Access Compliance Report

Public Rights-of-Way

Intersection ID: 11541	Main Street: W_9TH_ST	Cross Street: N_PINE_ST	Location: E
ADA ID: 33817FBD73ED	Ramp Type: PerpDiag	Initial Pass/Fail: Fail	Overall Compliance: No
		Severity Score: 12.5

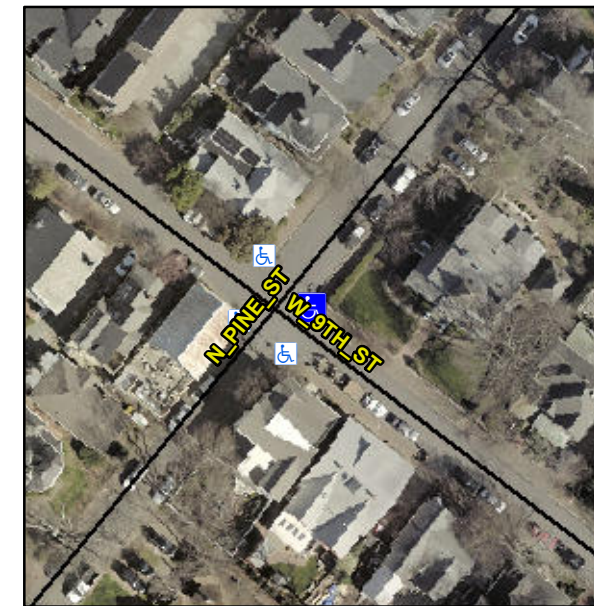
Not Found, R304.2.2

Compliance	Description	Data	Compliance	Description	Data
N/A	Ramp Length (in)	73.0	No	Ramp Slope (%)	10.7
Yes	Ramp Width (in)	48.0	Yes	Ramp XSlope (%)	1.5
N/A	Flare Type LT	N/A	N/A	Flare Type RT	N/A
N/A	Flare Slope LT (%)	N/A	N/A	Flare Slope RT (%)	N/A
N/A	Flare Traversable LT?	N/A	N/A	Flare Traversable RT?	N/A
N/A	Landing Length (in)	N/A	N/A	DWS Provided?	N/A
N/A	Landing Width (in)	N/A	N/A	DWS Contrast?	N/A
N/A	Landing Slope (%)	N/A	N/A	DWS Length (in)	N/A
N/A	Landing X Slope (%)	N/A	N/A	DWS Full Width?	N/A
N/A	Landing Curb? (Y/N)	N/A	N/A	DWS Offset (in)	N/A
N/A	Shared Landing?	N/A			
N/A	Gutter Ponding?	N/A	N/A	Gutter Slope (%)	N/A
N/A	Gutter Lip Ht (in)	N/A	N/A	Gutter X Slope (%)	N/A
N/A	Painted X Walk1?	No	N/A	Painted X Walk2?	No
	X Walk 1 Direction	To NW		X Walk 2 Direction	To SW
N/A	X Walk 1 Width (in)	N/A	N/A	X Walk 2 Width (in)	N/A
	X Walk 1 Slope (%)	4.4		X Walk 2 Slope (%)	2.4
	X Walk 1 X Slope (%)	1.3		X Walk 2 X Slope (%)	0.4

Remove & Replace Curb Ramp With Two New Directional Ramps or Equivalent.
